Wesleyan Methodist Chapel, High Street,  
Quorn, Leicestershire: Historic Building  
Impact Assessment.

**Report 2005/174**

A Planning Application has been submitted for the redevelopment of land adjacent to High Street, Quorn, Leicestershire. The proposed work includes the demolition of a Wesleyan Methodist chapel and the conversion of a later chapel into apartments, the construction of ten apartments, including one above a shop unit, and the building of a shop unit between 3 and 5, High Street (Planning App. No. P/05/2903/2).

Figure 6. Proposed ground floor plan.

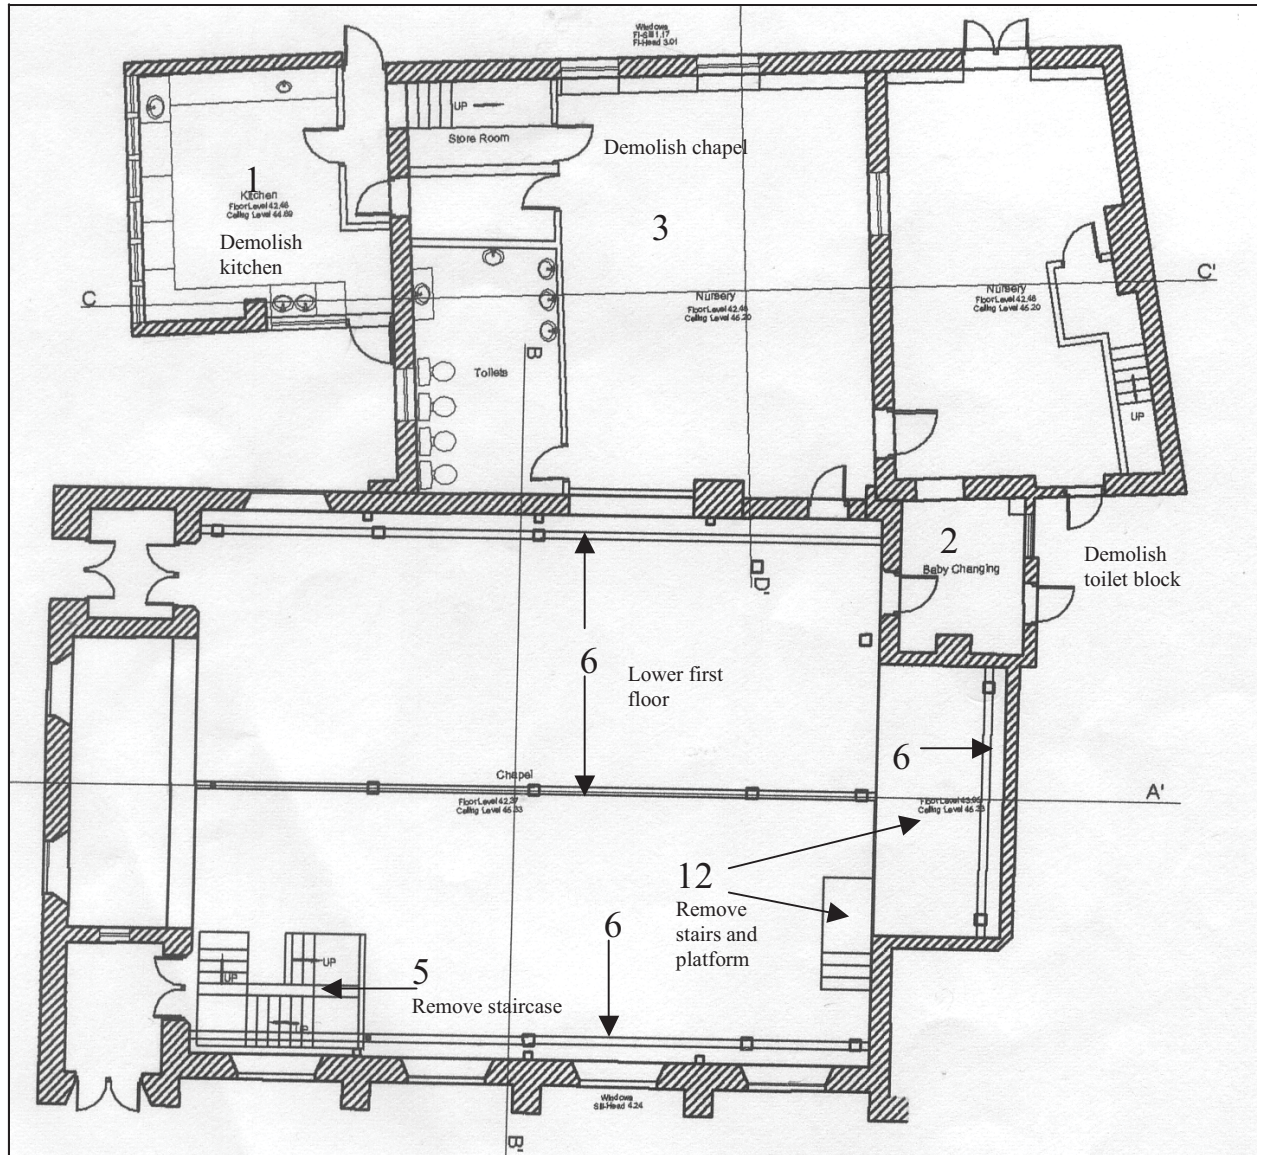
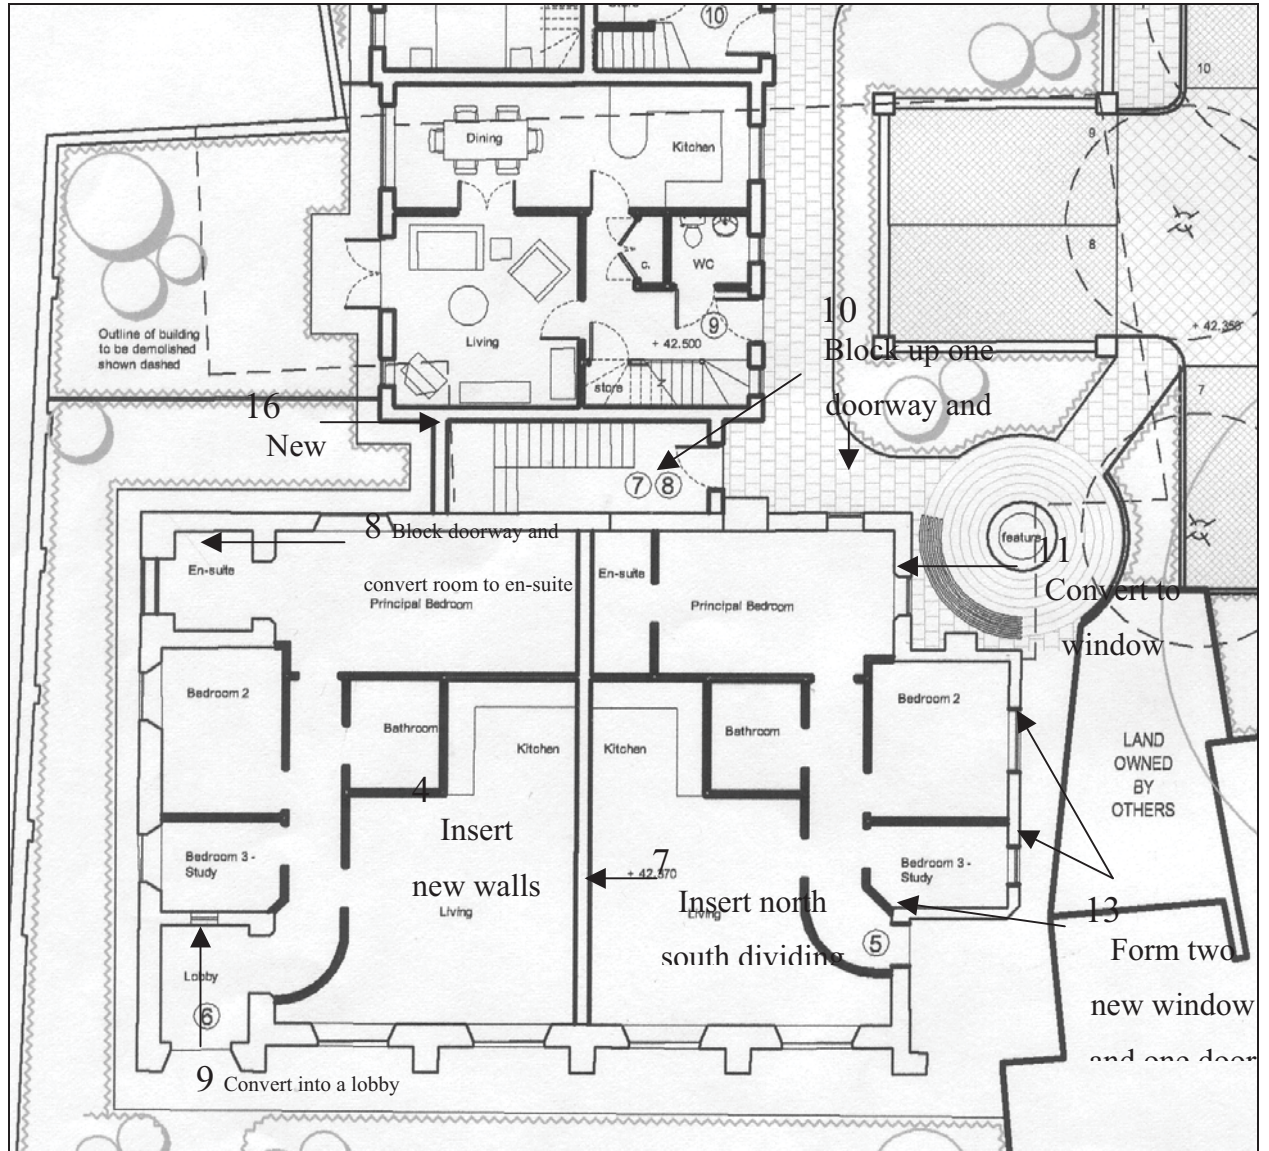
**4. Proposal:** remove existing internal walls and insert new ones to form domestic rooms.

**Assessment:** minimal impact, involving the removal of modern stud partition walls and insertion of new ones. No original wall fittings will be affected.

**5. Proposal:** remove staircase.

**Assessment:** minimal impact. Non-original staircase inserted recently during the buildings conversion to a nursery. During its construction one of the stone corbels supporting the roof structure of the chapel was damaged. The detached section remains within the building and the possibility of repairing it during any future work should be explored.

**6. Proposal:** lower the first floor.

**Assessment:** impact unclear. The plans indicate that the current floor supports will be removed. The impact of this will be minimal as they were put in at the same time as the staircase. However it is unclear how the new floor structure will be supported.

**7. Proposal:** insert a north south wall dividing the chapel in two.

**Assessment:** limited adverse impact. The proposed new wall will affect the original floor of the building though it will not affect any original internal fixtures and fittings such as skirting boards or wall decoration as these have already been removed. Clarification is required over how the new dividing wall will be tied in to the existing side walls. There will also be below ground implications that need consideration.

**8. Proposal:** conversion of the north-west porch into an en-suite that will involve blocking the entrance.

**Assessment:** impact unclear. Original wall fixtures and fittings survive including skirting, door frames and doors. Some clarification is required, both here and elsewhere in the building, for the treatment of such. Ideally original doors and door frames would be retained in their original positions during re-development. If original doors and door frames are removed do building and fire regulations permit the reuse of these elsewhere, for example where new openings are formed?

**9. Proposal:** conversion of the south-west porch into a lobby.

**Assessment:** impact unclear. Some original fixtures and fittings survive. As with the north-west porch clarification is required for the treatment of these.

**10. Proposal:** block the opening for a set of sliding doors and convert the adjacent door into a window in the north wall.

**Assessment:** minimal impact. Both doors are modern. They are located within partially blocked original arches that gave access to the earlier chapel.

**11. Proposal:** convert the doorway on the east wall in the north eastern corner of the building into a window.

**Assessment:** the conversion itself is of limited impact and it has been obscured from view from the exterior by the modern toilet block extension but when combined with **Item 13** and **Item 17** it will alter the appearance of the east wall significantly.

**12. Proposal:** removal of the stairs, ornate screen and wooden platform at the east end of the building.

**Assessment:** minimal impact. These features are not in their original setting and probably not in their original form. However, they have an ecclesiastical appearance and are likely to originate from within the building. Ideally they should be re-used in some capacity as they form a large element of the surviving fixtures and fittings from the later chapel.

**13. Proposal:** form a new doorway and two new windows in the east wall.

**Assessment:** significant adverse impact. Though the new openings will not impact on any internal features and only affect uniform brickwork, they will significantly alter the appearance of the building. The careful choice of windows in a deferential style will limit the potential impact of this proposal.

Figure 8. Proposed first floor plan.

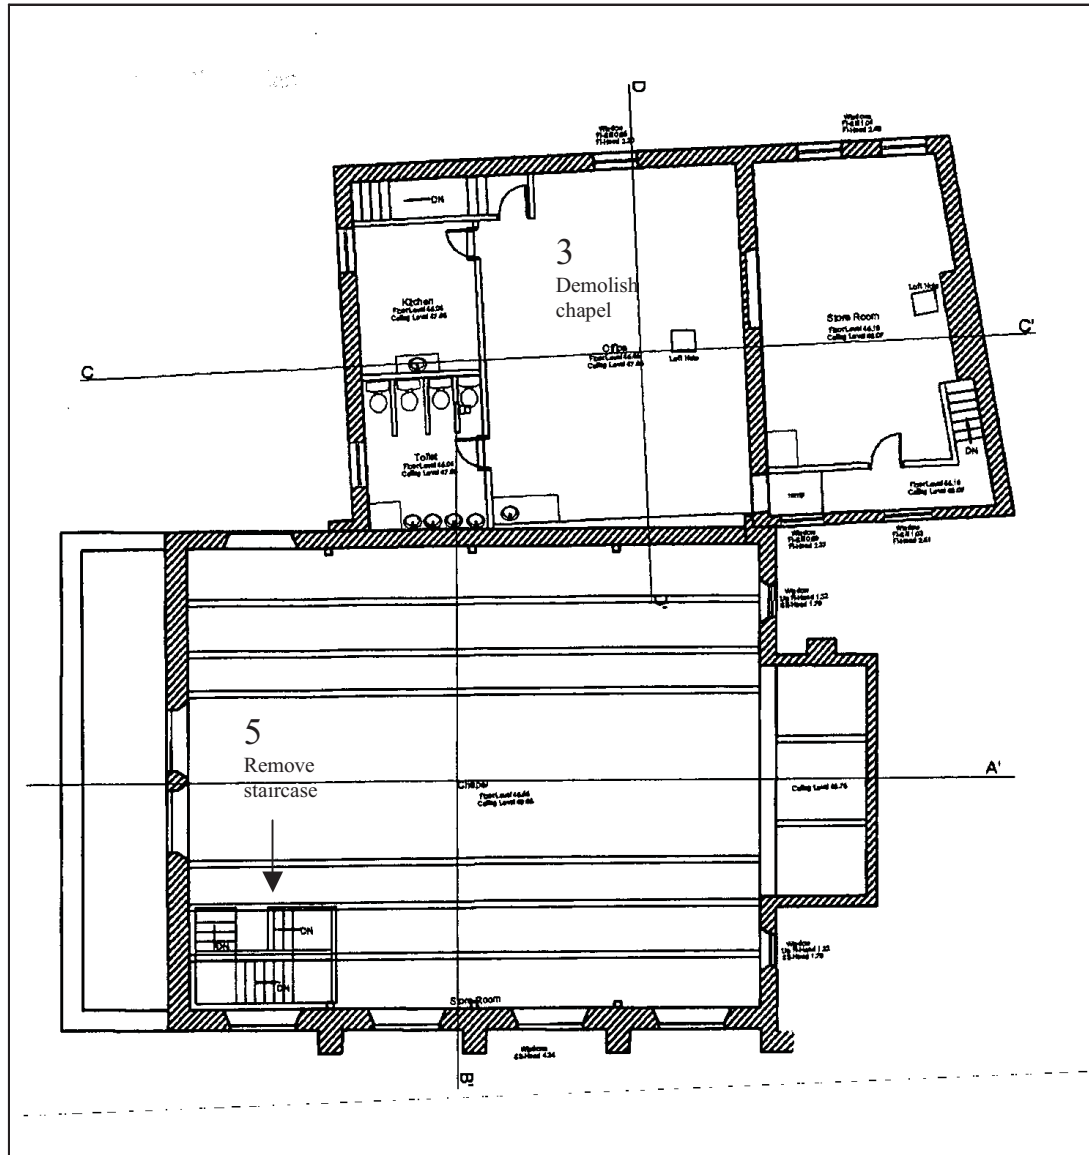
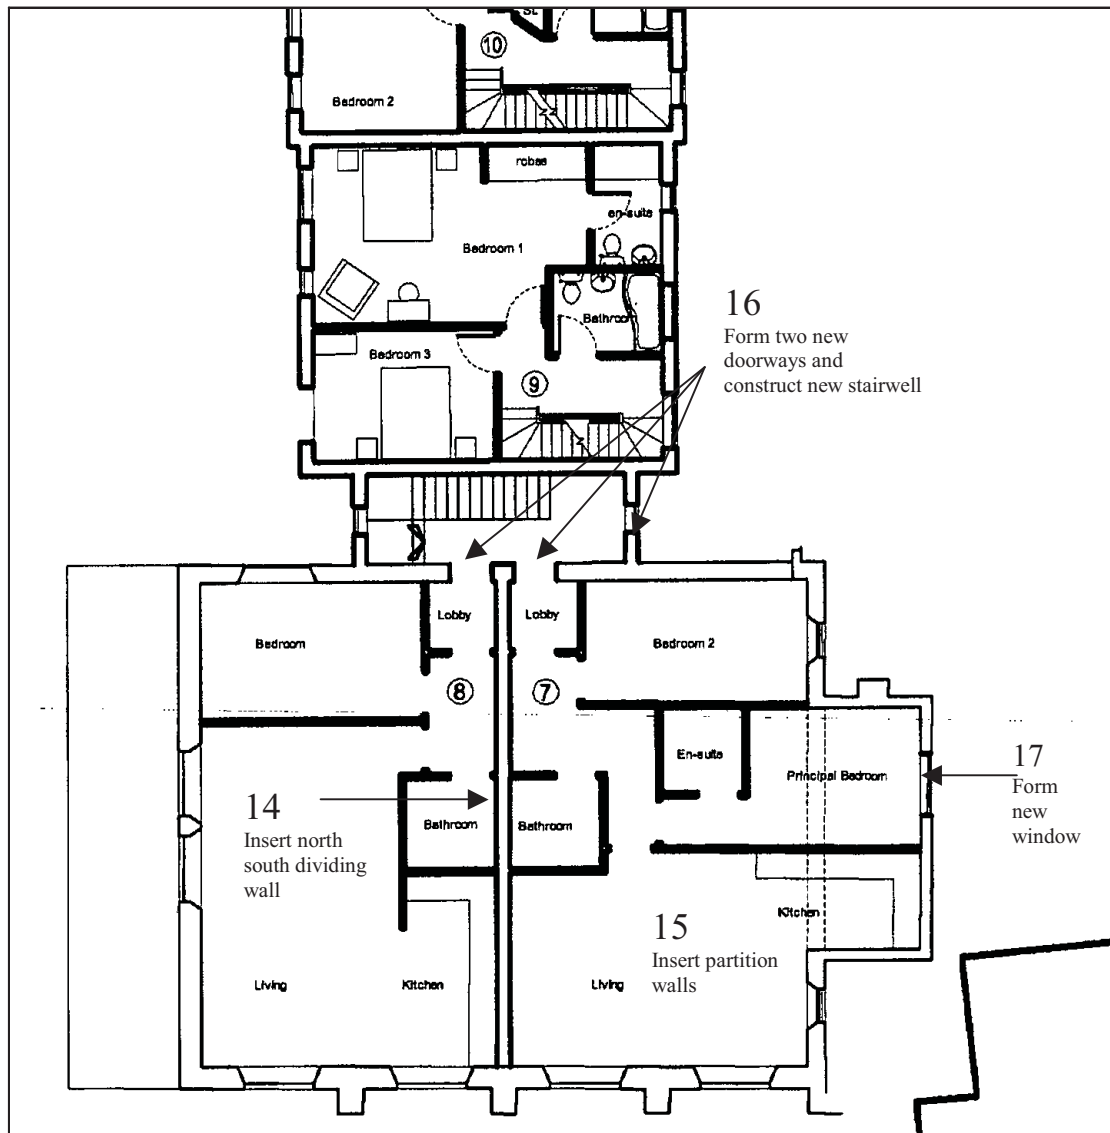
**14. Proposal:** Insert a north south wall dividing the room in two.

**Assessment:** impact unclear. This is the upper section of the wall that is being built to divide the building in two (**Proposal 7**). Clarification is required in order to determine whether there will be any impact on the roof structure.

**15. Proposal:** insert partition walls to form domestic rooms.

**Assessment:** minimal impact, involving only the sub-division of an existing space using stud partition walls. No original wall fittings will be affected.

**16. Proposal:** form two new doorways in the north wall for access to the new stairwell to ground level.

**Assessment:** significant adverse impact. It will presumably be necessary to tie the new stairwell to the existing fabric of the chapel. More significant however will be the alterations to the roof structure necessary to achieve this.

**17. Proposal:** form a new window in the east wall.

**Assessment:** significant adverse impact. When combined with the ground floor alterations to the east wall (**Item 12**) this opening will radically alter the appearance of the east wall.
